# MIAMI BEACH

### Staff Report & Recommendation

### Design Review Board

SUBJECT: DRB21-0657  
**2145 North Meridian Avenue**

Lot 24, Block 1 Original Plat of February 6, 1920.

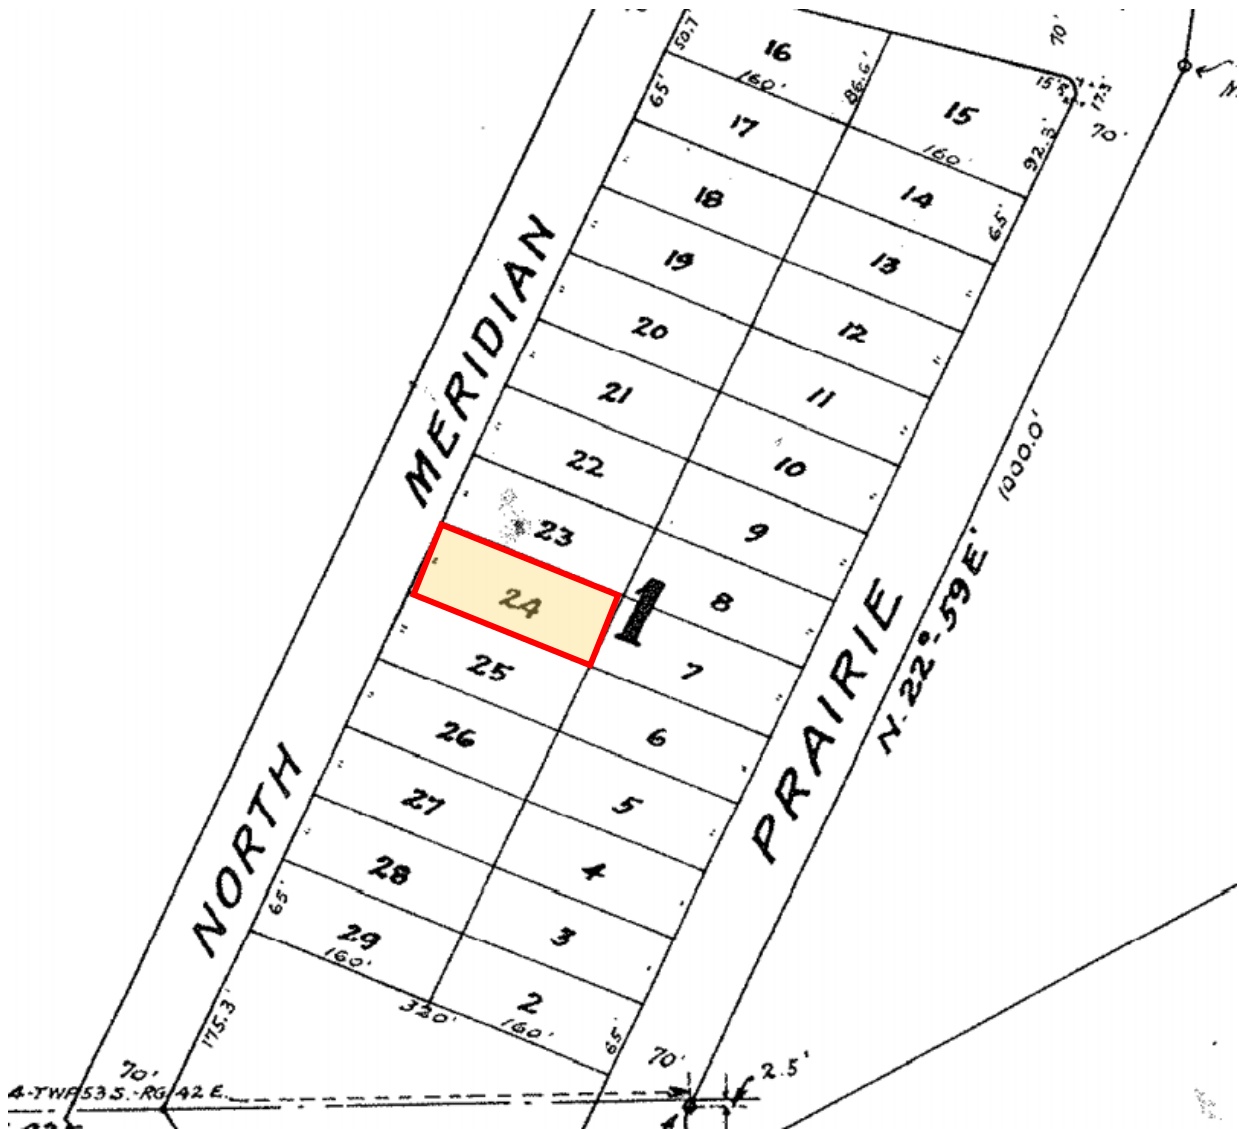
The subject property is a mid-block parcel, adjacent to the Miami beach Golf Course, and originally platted as Lot 24 on Block 1, of the Mid-Golf subdivision of Miami Beach Shore Company which was historically platted on February 6, 1920 with standard lots measuring 65'-0" wide by 160 feet deep. At some time in the past, 5'-0" of the north side of the property was transferred to lot 23 on the north side of the parcel.

Today the lot is 60 feet wide and 160 feet deep and contains a lot area of approximately 9,587 SF. The RS-3 zoning district requires lots to have a minimum lot area of 10,000 SF in order to be a developable parcel and a variance is being requested to develop a site that is less than 10,000 square feet.

Section 118-390 of the City Code, pertaining to nonconformances, provides that "legally established" means a lot that does not meet the lot frontage, lot width, lot depth, and/or lot area requirements of the current zoning district, provided that such lot met the regulations in effect at the time of platting. While this property is part of lot 24 of Block 1 of the original 1920 plat of Mid-Golf subdivision of Miami Beach Shore Company, the site was originally platted with a lot width of 65'-0" and approximately 10,400 sf of area, similar to the adjacent properties.

It is not clear when the property was reduced in width to 60'-0" and that portion was transferred to the adjacent lot 23 on the north side. The applicant has provided a property deed dating from 1972 showing the property width of 60'-0". Staff would also note that current records of Miami-Dade County note this property with a width of 60'-0". Based on the evidence provided and staff research, it appears that the current size of the lot has been established for a very long time. Without the granting of this variance, the construction of a new residence, or any structure for that matter, would not be permitted on the property and the site could not be developed as other lots in the same district. Staff finds that the size of the lot, as it exists today, creates the hardship that justifies the variance request and recommends approval of the variance.
